From: Stan Sims <stan@stansimslaw.com>
Sent: Wednesday, November 2, 2022 11:35 AM
To: St Germain, Dante
Cc: john@bardlaw.com
Subject: RE: 22-0057 and Stan Sims

My name is Rob Furlong and I live at 4819 Walnut Hills Drive. I am writing to express my objection of rezoning 4700 S Hurstbourne Pkwy and 4900 S Hurstbourne Pkwy. If approved by the Planning Commission and/or by our City Council, this will violate KRS 100, the Land Development Code, and Plan 2040.

Please do not approve 22-ZONE-0012 and 22-ZONE-0076. The karst report and the geological report support the development will alter the terrain, the water, and cause new sinkholes / caverns. The property in question is not suited for development and will cause undue harm and risk to my home, my family, and my neighbors.

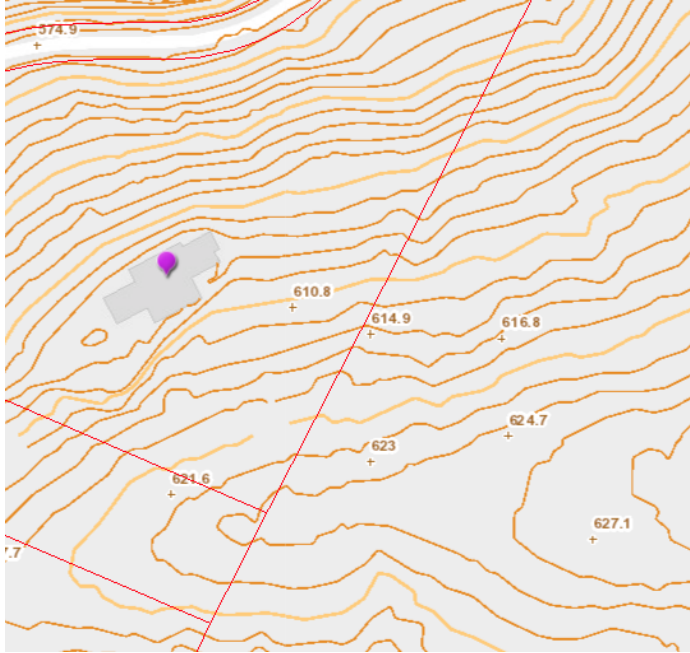
- According to section renderings, these massive 55-foot buildings are on land that is already 10 to 15-feet higher than adjacent properties. There may also be an additional 8-feet of backfill required (per geotechnical study and neighborhood meeting). Thus, these buildings will appear 78 feet to us who live below. See figure 3.1.

- For an *additional* 100-feet to be added to the setback along the North (Laurel Springs) and West (Walnut Hills Dr) sides of the property.
- Include a 6-foot berm with a 6-foot privacy fence and trees around the entire perimeter of the development at 4700 S Hurstbourne Pkwy and 4900 S Hurstbourne Pkwy.
- Leave the natural buffer along Laurel Spring Dr alone. See figure 3.4.

Figure 5.3 - Fern Creek is a FEMA Regulatory Floodway

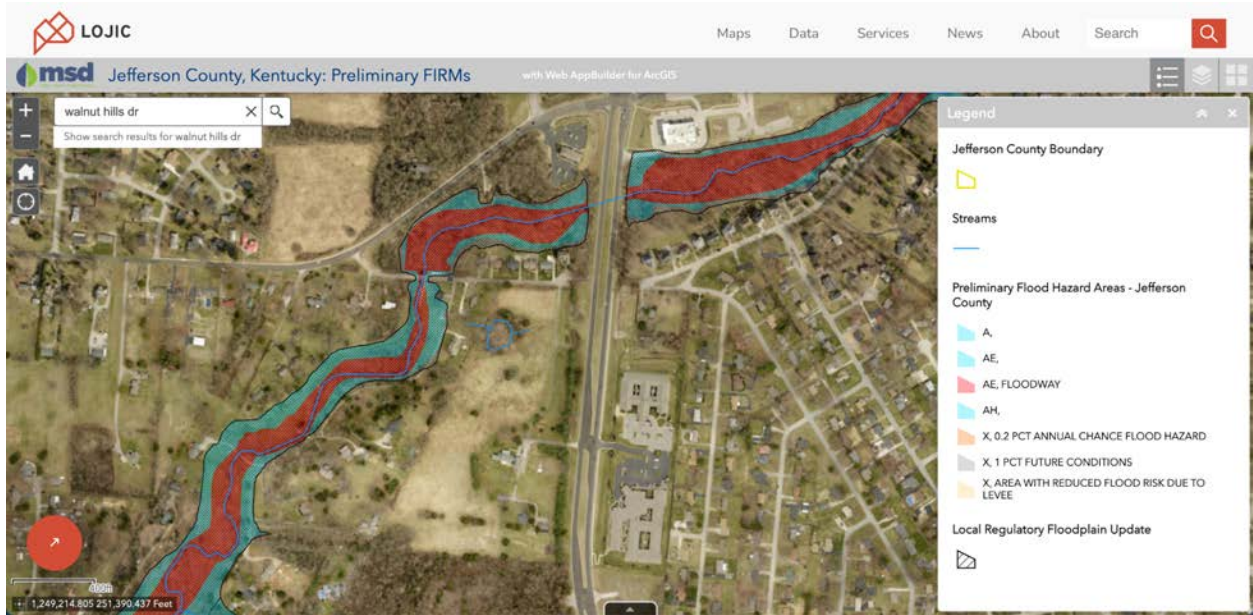
- According to Lojic Online, 4700 S Hurstbourne Pkwy is nearly surrounded by steep slopes, unlike any other development on Hurstbourne. See figure 5.2
- Due to our waterway being a FEMA Regulatory Floodway, surrounding properties are to be further regulated (according to FEMA). While the developer's property does not directly abutt to the creek, every single-family home surrounding it does. See figure 5.3

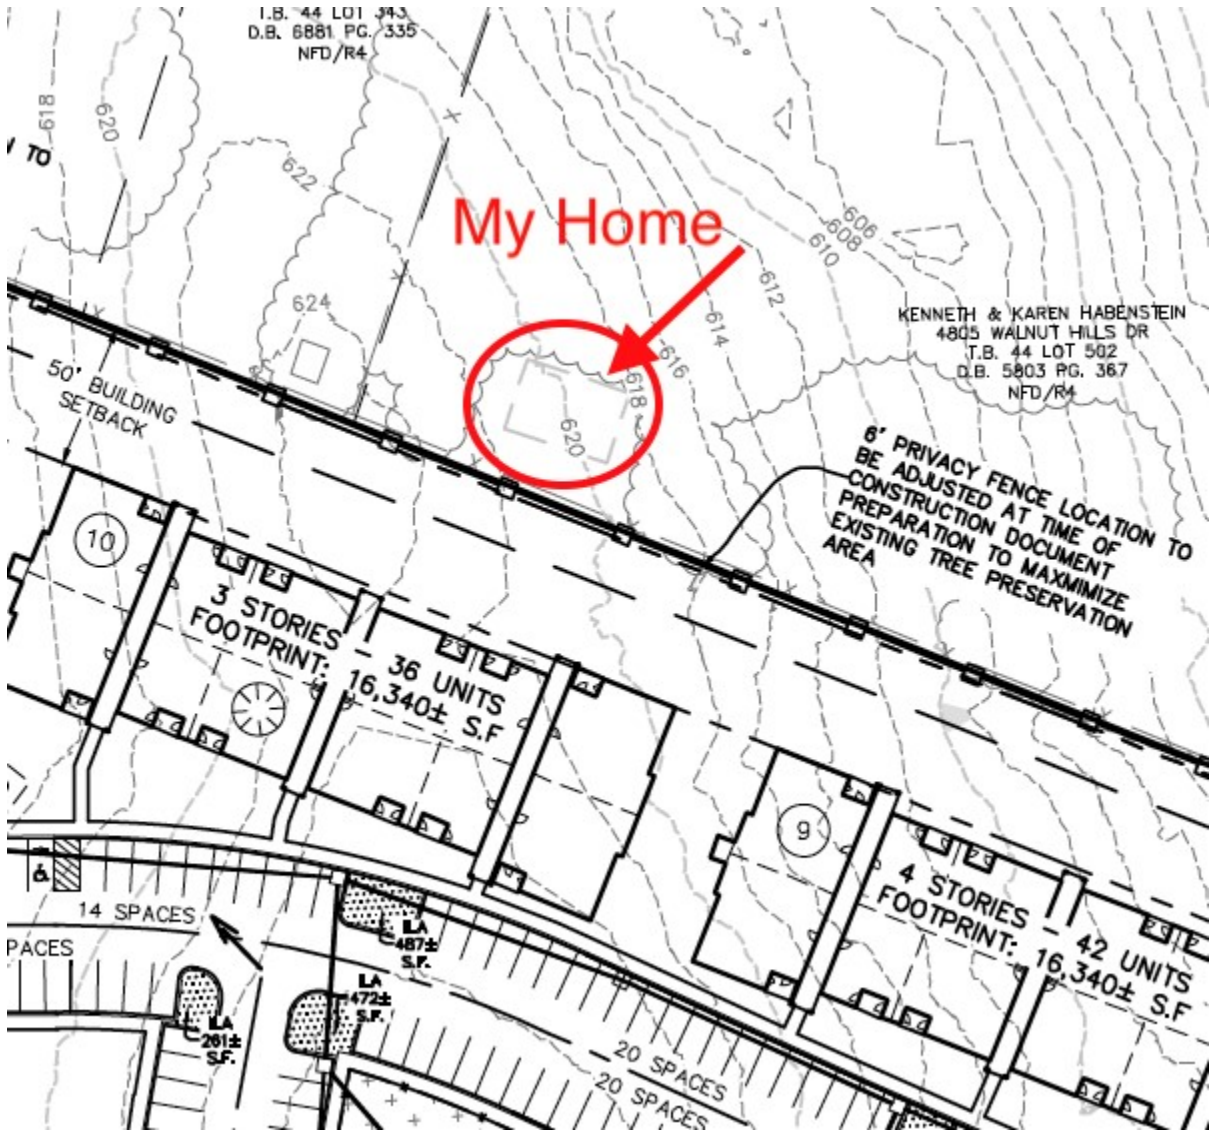
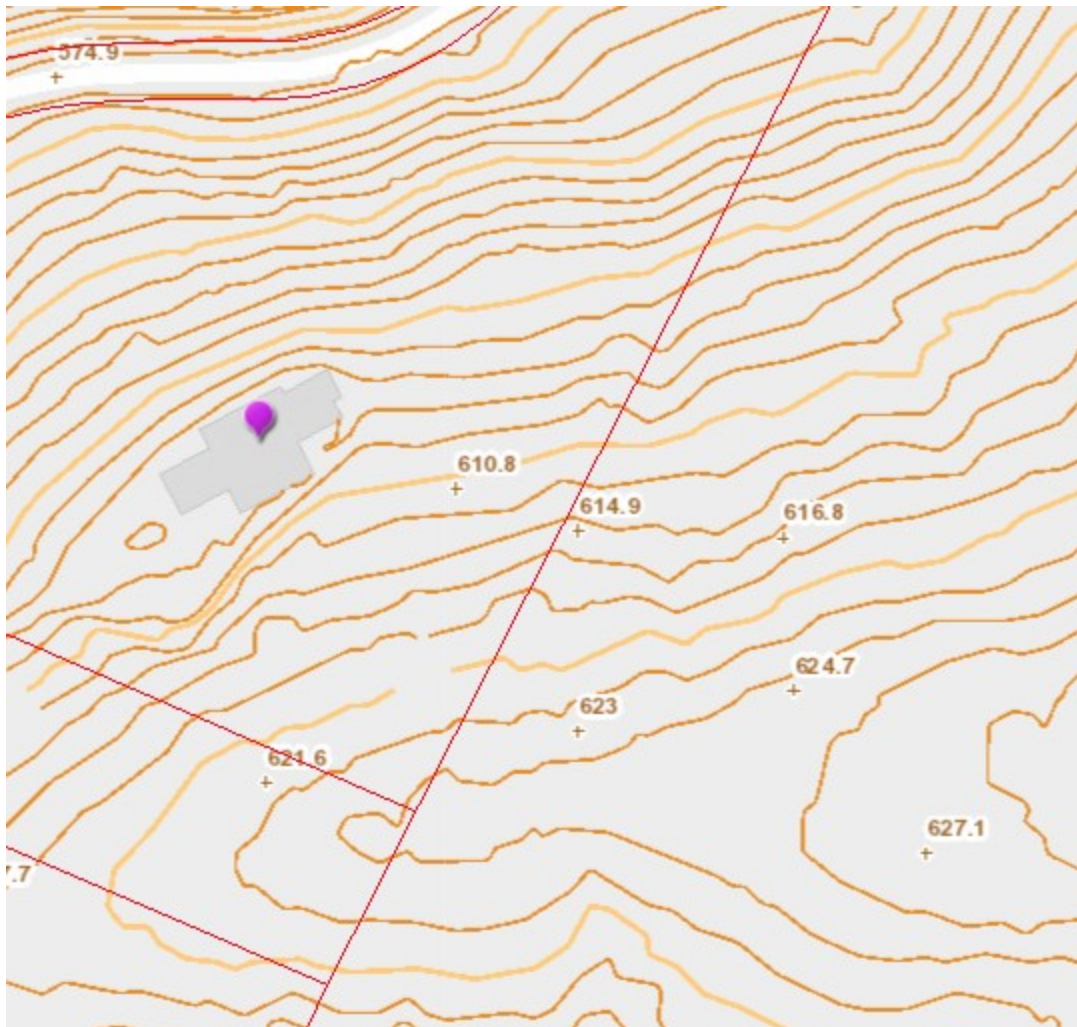
First and foremost, the developer has proposed 3-story and 4-story buildings towering over my home, with only a 6-foot fence to set us apart. These buildings are literally right on top of my home and the balconies will be looking directly into all my bedrooms, living room, and kitchen, in addition to my outdoor patio area, which is very important to us.

Because my home is downhill from these buildings, they will appear even larger from my view as my home is sloped downhill from this development.

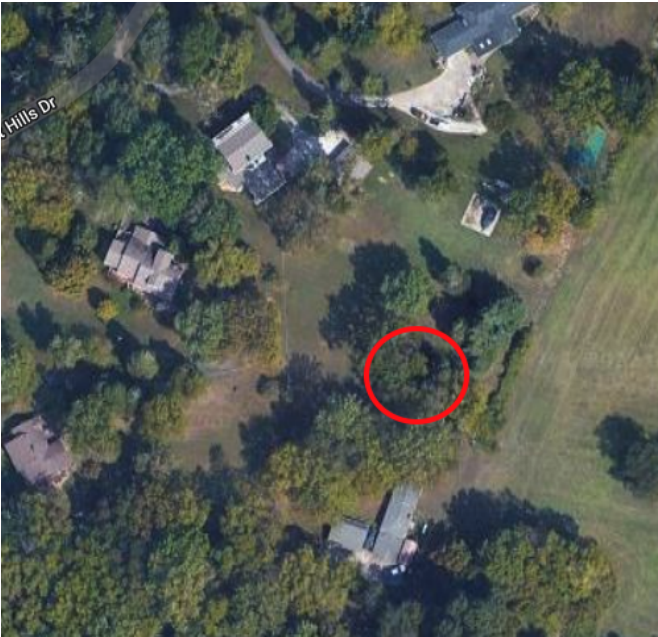
It appears as though the developer has proposed to send water toward my house and the existing sinkhole. I am extremely concerned about how this will affect my home. It is known that modifying the natural flow of water on karst terrain can damage nearby structures.

If the developer were to build a berm in this area, it could theoretically help mitigate damage done to my home (and preserve our existing privacy). We've asked the developers to do this several times but they unfortunately have ignored our request.

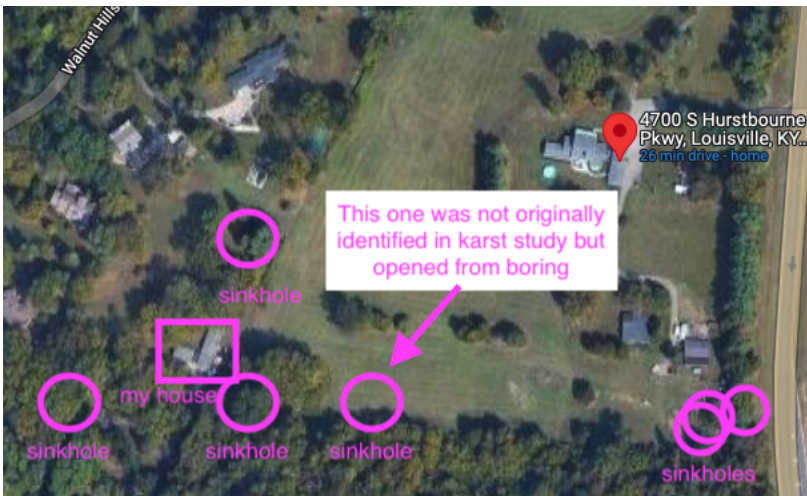
"Encourage development to avoid wet or highly permeable soils, severe, steep or unstable slopes where the potential for severe erosion problems exists in order to prevent property damage and public costs associated with soil slippage and foundation failure and to minimize environmental degradation."

There are many collapsed sinkholes in the abutting neighborhood and on the proposed property itself.

In fact, we have reason to believe there may be an underground cave or stream that flows from the 4700 S Hurstbourne Pkwy property, beneath a residents house (pictured left), and ends up in the protected creek below.

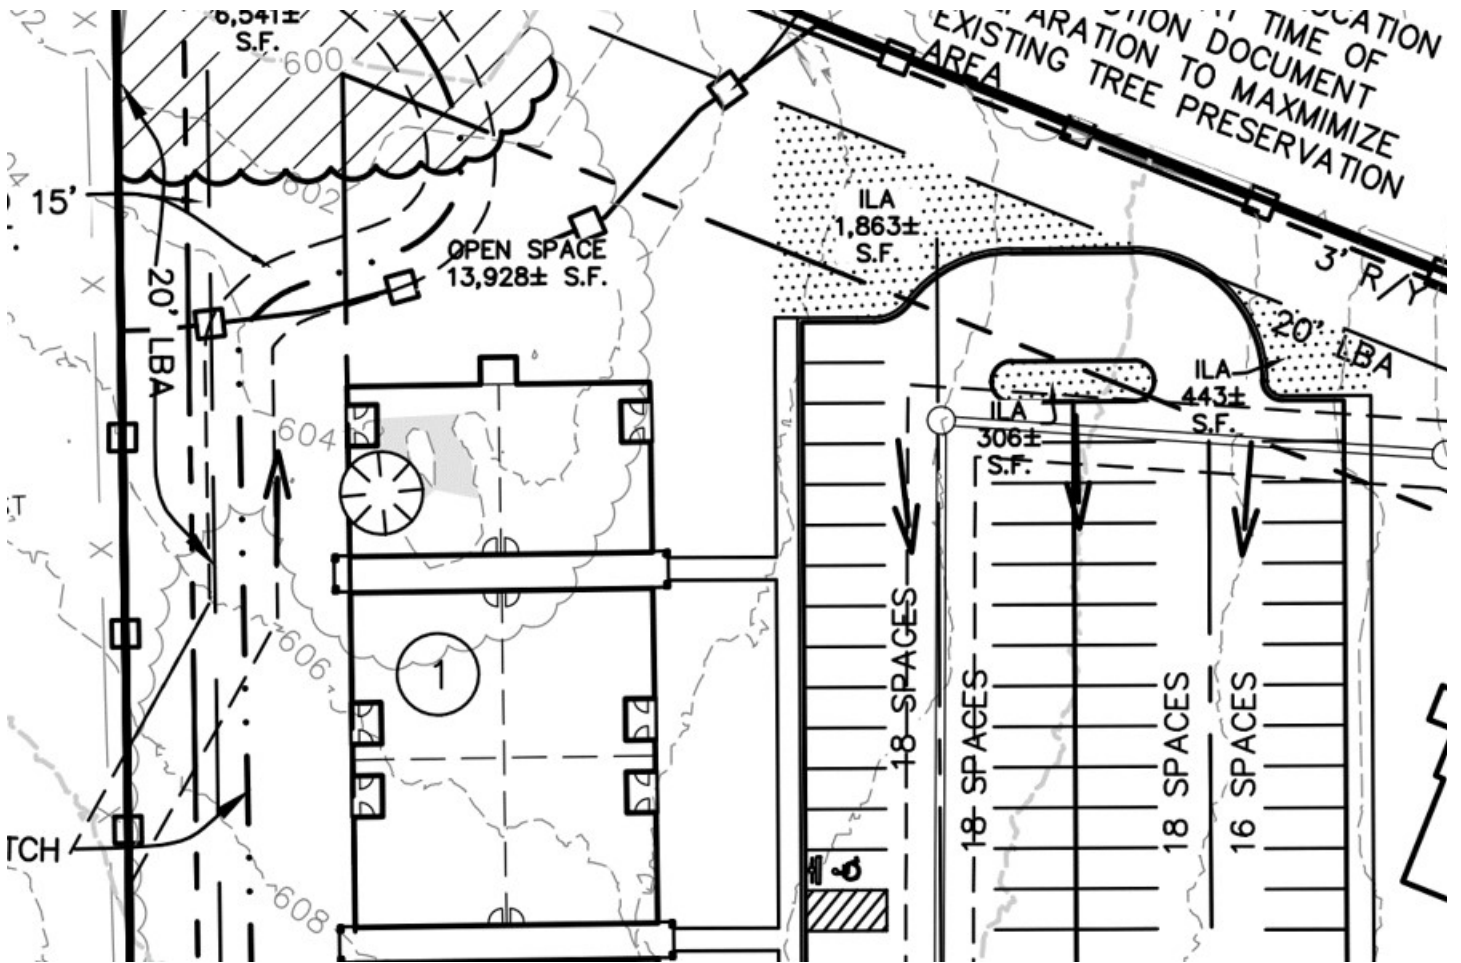
Hi Ms. Germain. I have been looking at the plan uploaded just after the Geo Survey. The plan makes it look like building 1 is at 604 ft but pretty sure the developer plans on lots of fill dirt and raising the area 20 ft or so.?? Is that normal to not disclose the terrain height? If I am correct, building 1 will be 20 ft or so above the recorded 604 height as well as the parking lot? Then a 35 ft building on top of that. Hard to tell the developers intentions, but if I am right, the parking lot will be above the fence and the powerlines below and on the southwest corner. Seems lots of important information is missing.

I am also curious about the Karst study and the geological study. They both indicate they were performed with no more than a 3 story building being considered, however, the developer appears to be planning 4 story buildings. Why was this information held back from the Karst and Geo study. Neither of these very important studies were based on the intents of the developer. Will new studies be performed based upon the new intensions of the developer?
